CONNECTION PLATE

it's our pleasure to inform you that we will deliver a **new connection plate** for the TOORS GUARDY residential door with the standard track system (SL 350 and SL 420) since August 1st, 2014. The new connection plate guarantees a more solid connection between the vertical angle and the bearing plate.

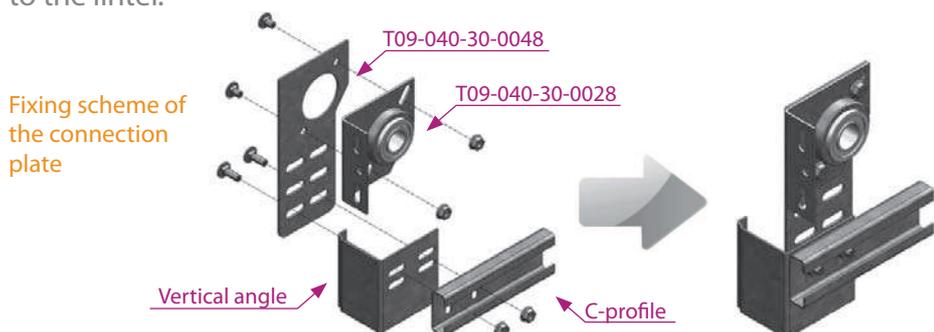
The couple of bearing plates so far used in the residential doors is replaced by a couple of preassembled bearing plates and connection plates for left and right side.

Current solution with single bearing plates (BaaN Code No. T09-040-30-0028 and T09-040-30-0029) requires the complete shaft construction to be entirely fastened onto the lintel. The lintel had to be perfectly solid to be able to carry the whole mass of the shaft and the door leaf. The new T09-005-0049 and T09-005-0050 sets are connected with the vertical angle and the C-profile by screws. Due to this connection the load is split between the vertical angle and the bearing plates fixed to the lintel.

- New plates for TOORS GUARDY (SL 350, SL 420)
- More stable installation of the shaft
- Both shaft and door leaf mass can be transferred onto the vertical angles
